# APPROVED ELEVATIONS

## AS BUILT ELEVATIONS

CLIENT	BRAMHALL GOURMET		
SITE/CONTRACT	PROPOSED DELI PATISSERIE 1 BRAMHALL LANE SOUTH		
TITLE	EXISTING AND PROPOSED ELEVATIONS		
DATE	JAN 19	SCALE	AS SHOWN
CHECKED		DRAWN	40262 / 04C /

CLIENT	BRAMHALL GOURMET		
SITE/CONTRACT	PROPOSED DELI PATISSERIE 1 BRAMHALL LANE SOUTH		
TITLE	EXISTING AND PROPOSED PLANS		
DATE	JAN 19	SCALE	AS SHOWN
CHECKED		DRAWN	40262 / 03B /

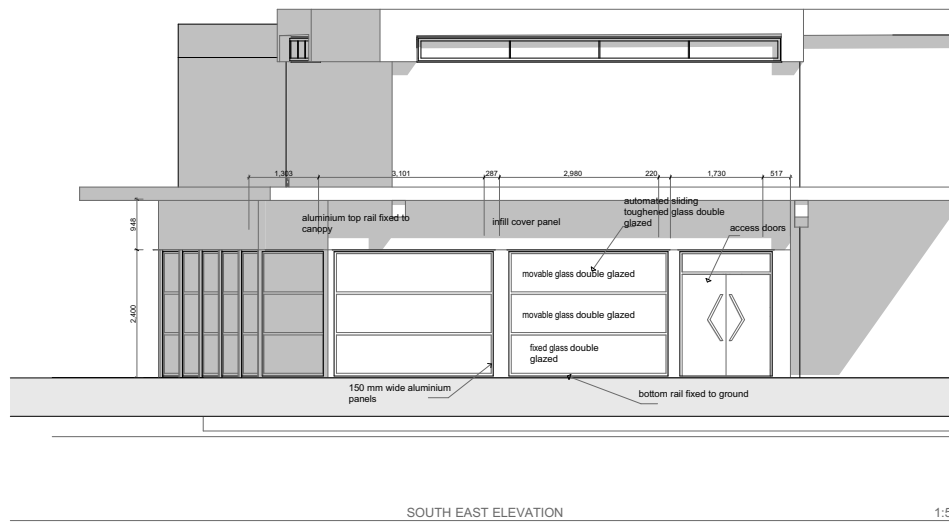
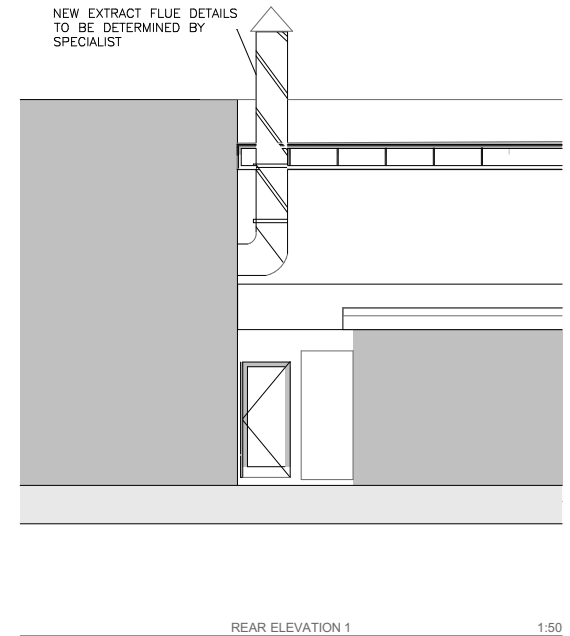
Appropriate action is to be taken as regards noise and odour. Details to be provided by a specialist company.

The following details are to be confirmed;

1. Canopy Size
2. Size and number of filters fitted into the canopy.
3. Cooking equipment list, including any table or worktops
4. Size of the equipment length x width
5. Length of ducting, number of bends and type of bends.

the following information is confirmed by specialist kitchen company.

1. stainless steel extraction canopy to MUCA DW/171
2. Odour control based on guidelines set out by DEFFRA.
3. Woods 500 dim axial fan.
4. 450 mm spiral duct to 1m above the eaves level.
5. Noise levels based on guidelines as set out by the World Health Organisation (WHO)
6. NOISE DATA
  - LOW 24 dba at 3 m free field
  - HIGH 51 dba at 3 m free field

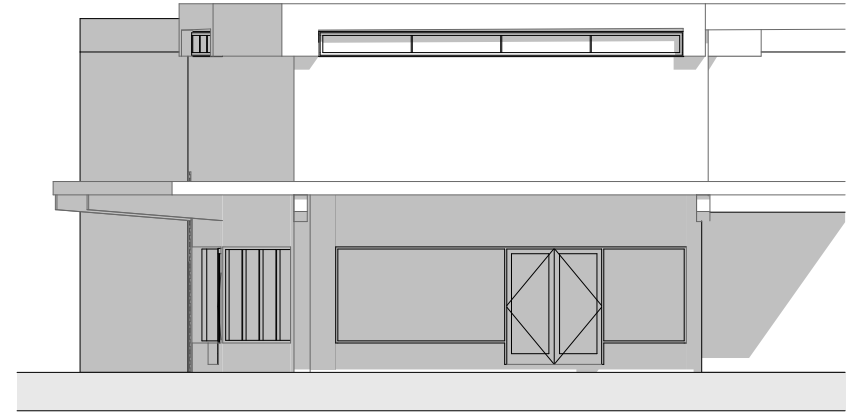
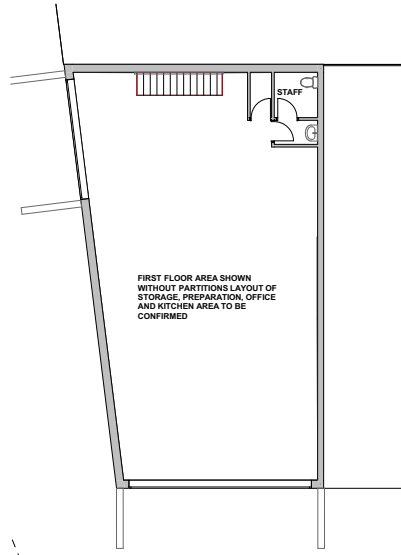
Rev C. Amend access door arrangement, including plans and elevations 18/11/20  
Rev B Amend screen and fascia detail. 16/05/19  
REV A Adjust screen location by 300mm on Ack Lane East frontage. 23/04/19

CLIENT	BRAMHALL GOURMET		
SITE/CONTRACT	PROPOSED DELI PATISSERIE 1 BRAMHALL LANE SOUTH		
TITLE	EXISTING AND PROPOSED PLANS		
DATE	JAN 19	SCALE	AS SHOWN
CHECKED		DRAWN	40262 / 03F /

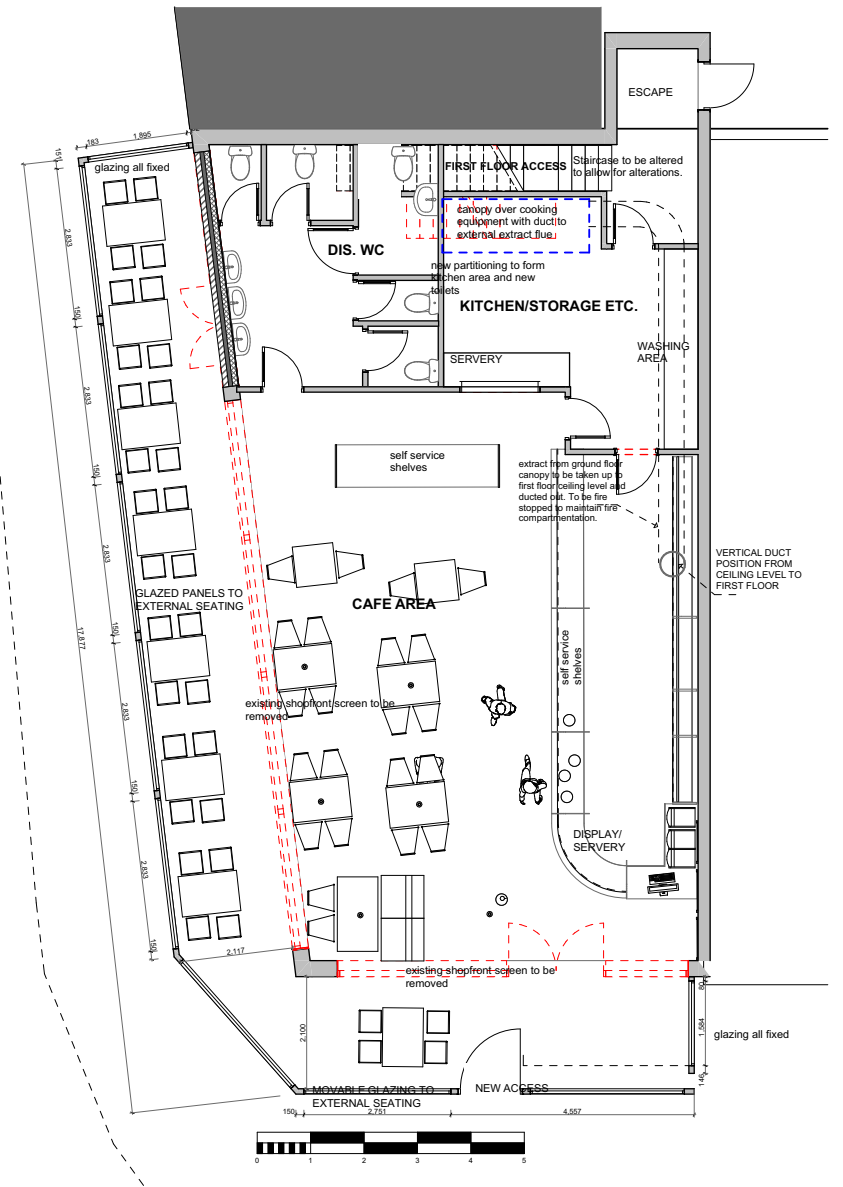
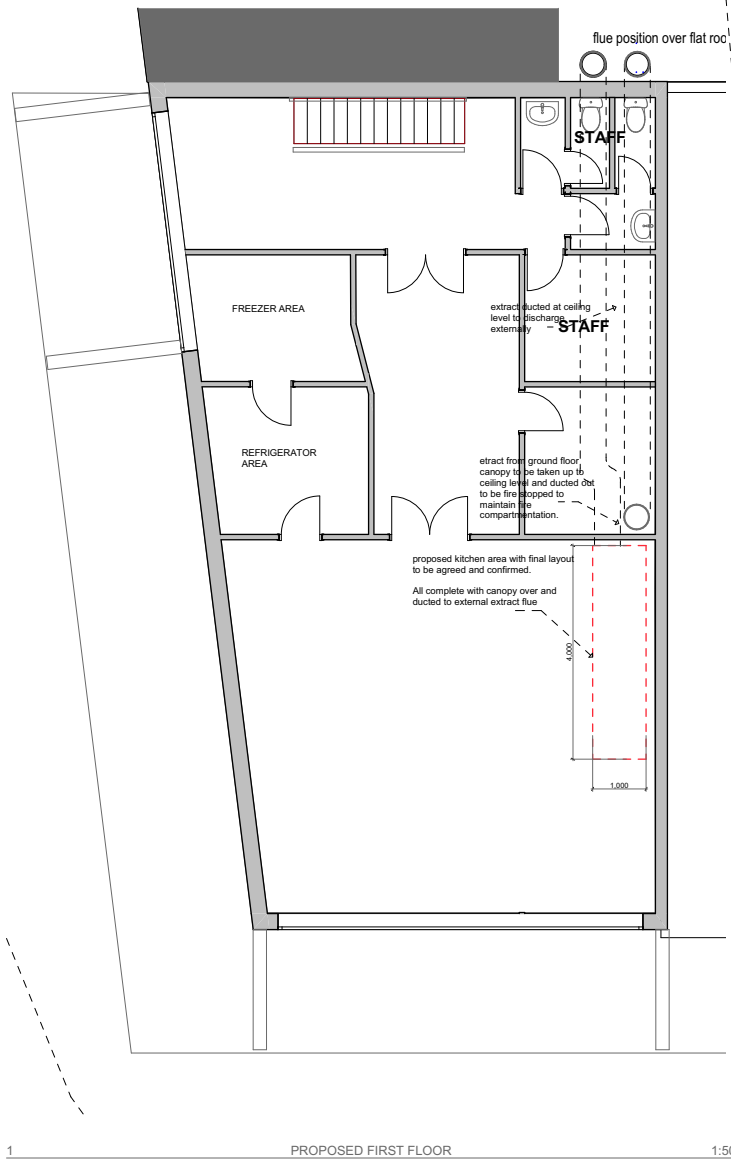
Rev F. Amend access door arrangement, including plans and elevations 18/11/20 1:50

- Rev E. Add detail to fascia amend extract. 28/05/19
- Rev D update layout 28/05/19
- Rev C Amend screen and fascia detail adjust layouts. adjust extract layout 16/05/19
- Rev B Adjust screen location by 300mm on Ack Lane East frontage. 23/04/19
- REV A Update drawing 26-02-19
